FIELD REPORT

PROJECT:	Webster University Interdisciplinary Building	SWT DESIGN REPRESENTATIVE:	Zach Snovelle Alicia Heis
PURPOSE OF TRIP:	Site Inspection	SUBMITTED TO:	Cannon Design
DATE ON SITE:	4/24/2017		
LOCATION:	Interdisciplinary Building

On April 24, 2017 SWT Design visited the Interdisciplinary Building site to review rain garden and green roof construction. Comments follow, are numbered and refer to the attached sketch and photos.

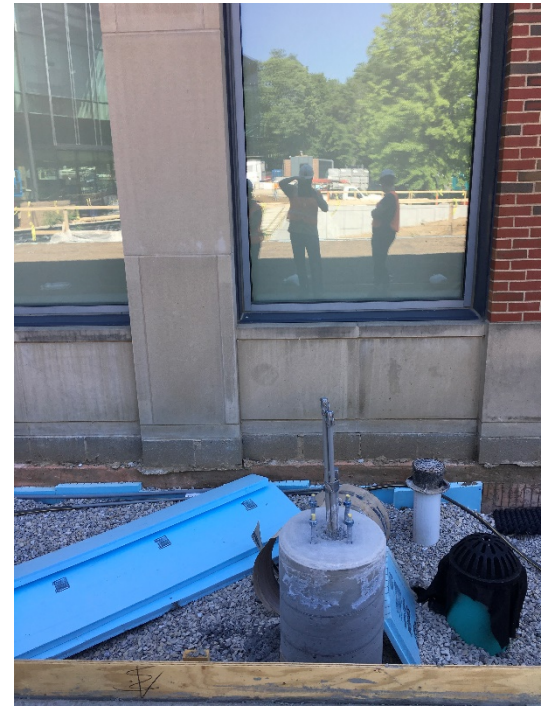
ITEM	DESCRIPTION	
1.	Tree protection fencing in need of repair.
